SUBJECT: Central Illinois Regional Airport
Bloomington, Illinois
McLean County
Illinois Project Number: BMI-4776
AIP Project Number: N/A
Contract No. BL072
Item No. 04A, March 8, 2024 Letting
Addendum A

NOTICE TO PROSPECTIVE BIDDERS

REHABILITATE AIRPORT
ENTRANCE ROAD AND
ASSOCIATED IMPROVEMENTS

SHEET TITLE
AIRPORT SITE PLAN

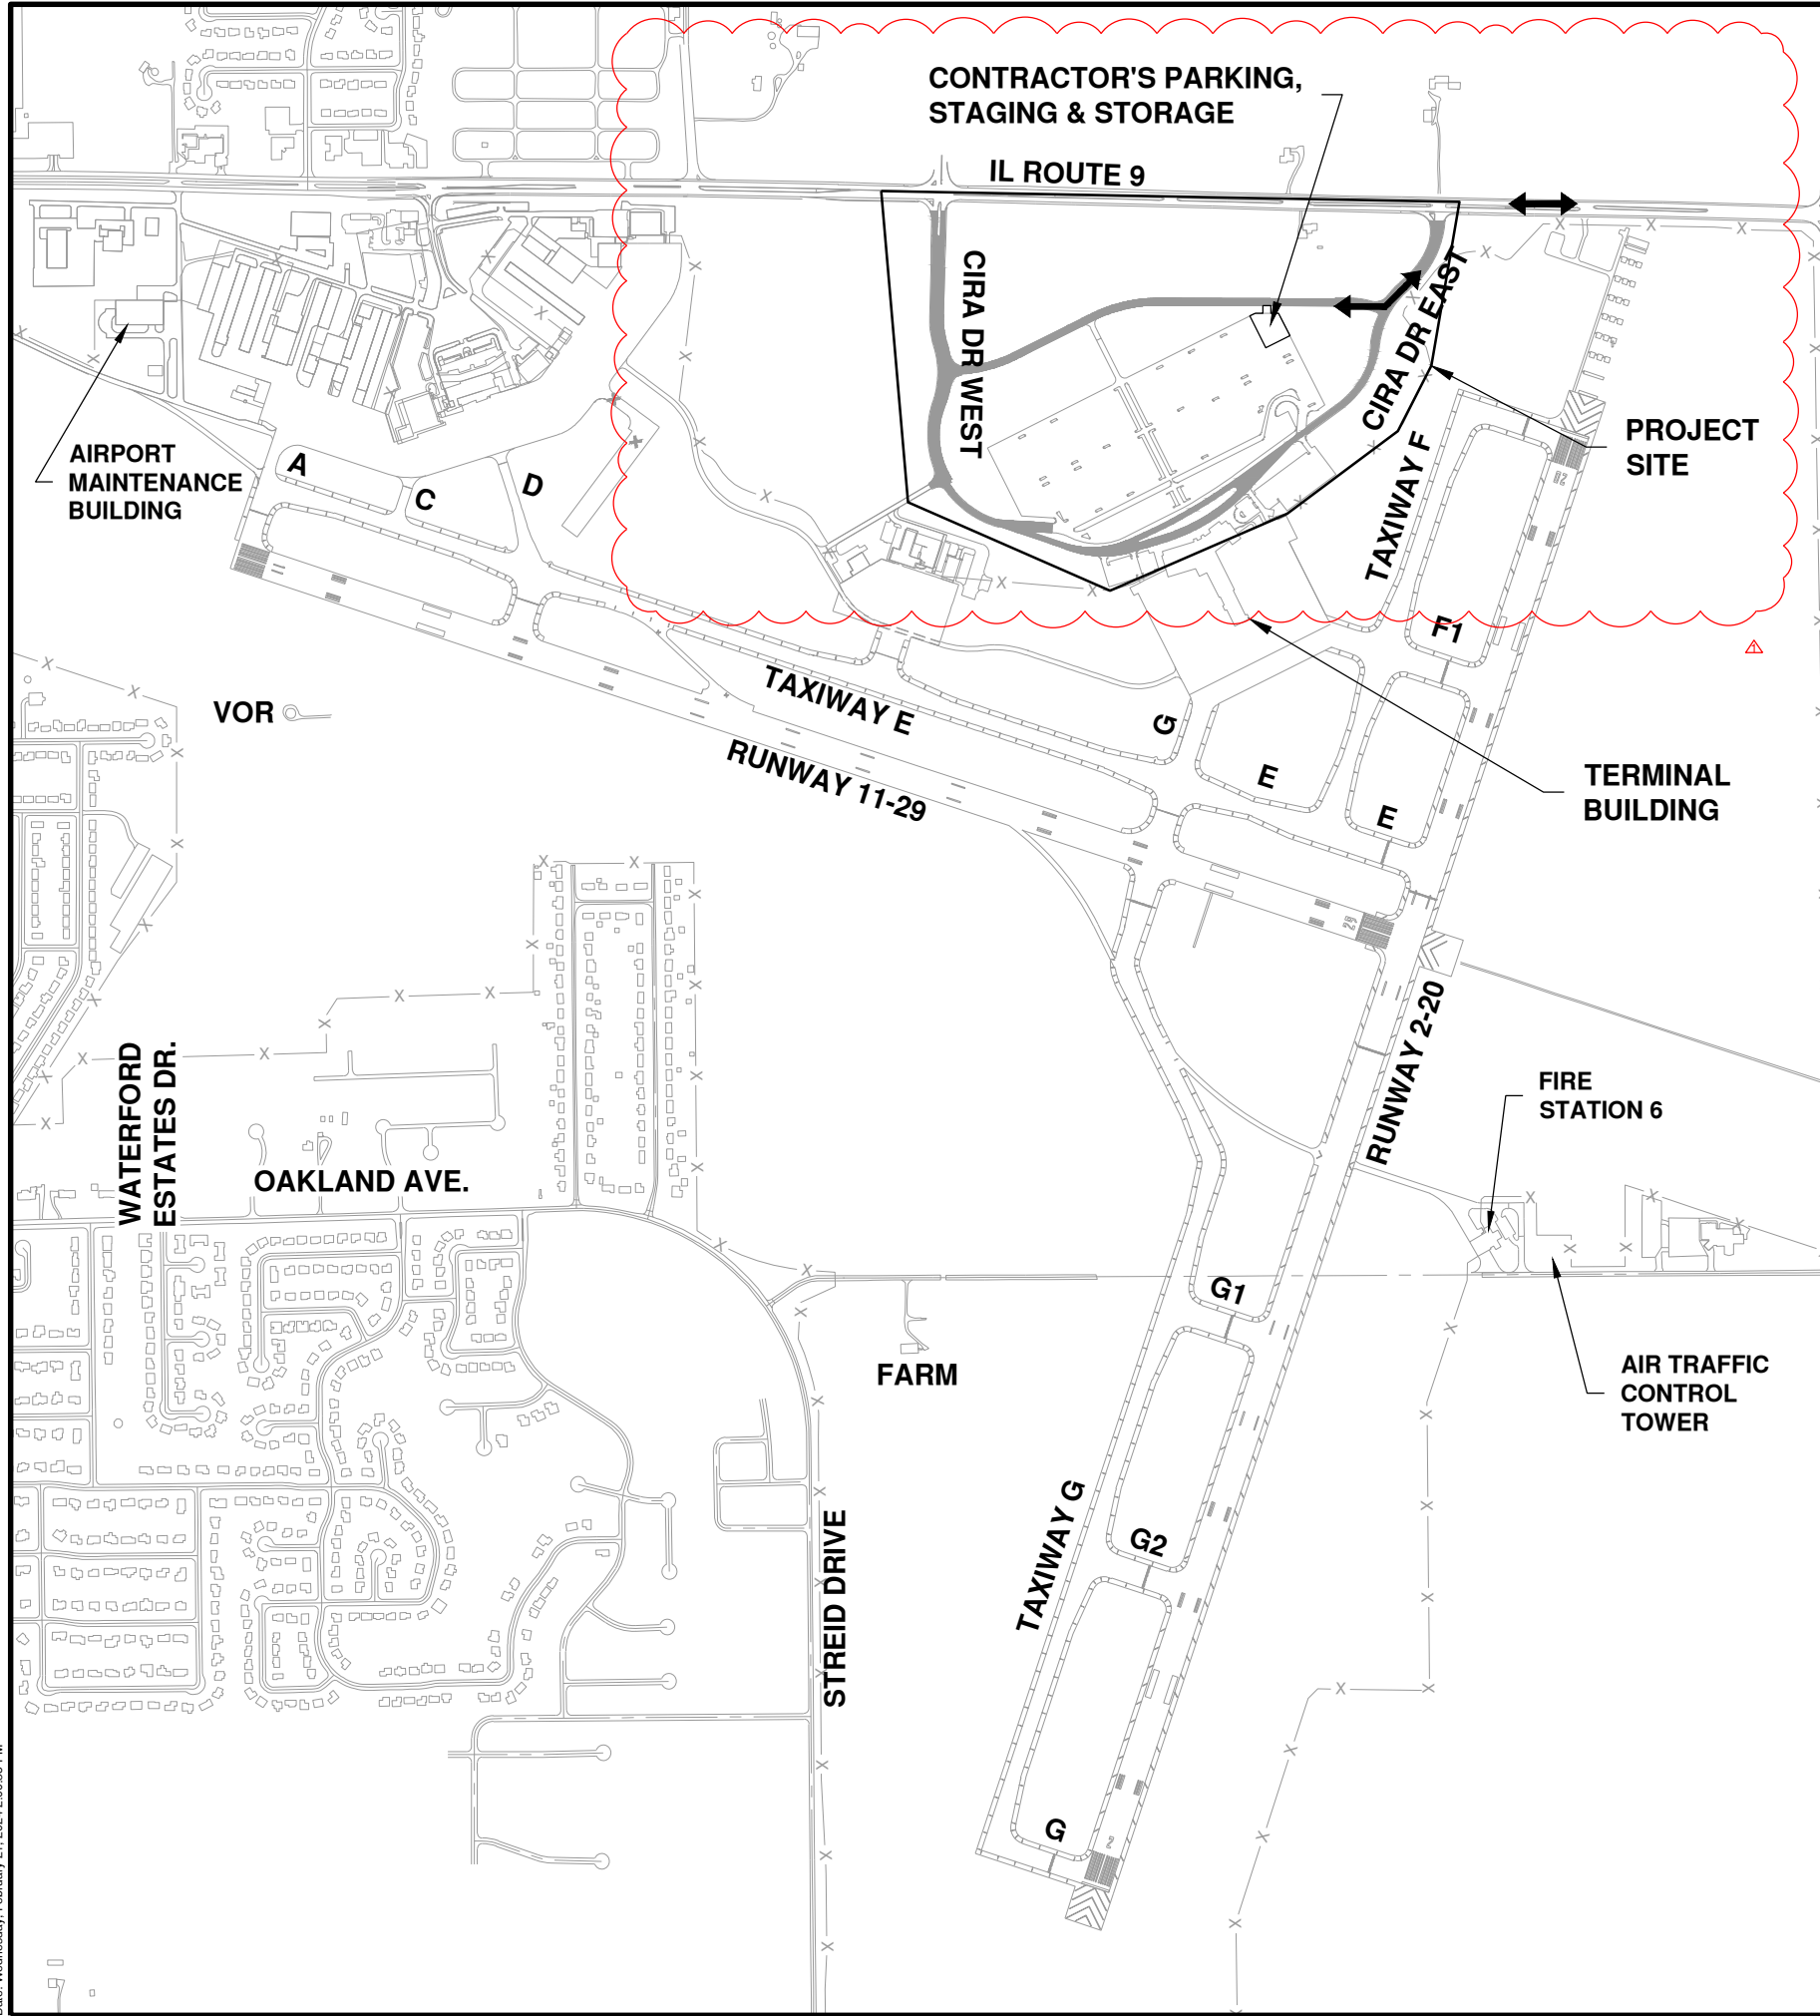
- Sheet GI002
 - ADD: Pay Item AR401630, Bituminous Surface Test Section
 - ADD: Pay Item AS401630, Bituminous Surface Test Section
- Sheet GI101
 - REVISE: Location of Contractor's Parking, Staging, and Storage.
- Sheet GC101
 - REVISE: Location of Proposed Staging and Storage Area.
 - REVISE: Critical Point Table – Staging and Storage.

1. EQUIPMENT HEIGHTS **GREATER THAN 25'** SHALL NOT BE USED WITHOUT COORDINATION WITH THE RESIDENT ENGINEER AND AIRPORT OPERATIONS.
2. CONTRACTOR SHALL ACCESS SITE THROUGH CIRA DRIVE EAST.
3. CONTRACTOR SHALL INSTALL TEMPORARY ACCESS TO PARKING, STAGING, AND STORAGE AREA, AND RESTORE AREA IN KIND AT THE END OF THE PROJECT. ALL WORK SHALL BE CONSIDERED INCIDENTAL TO MOBILIZATION.
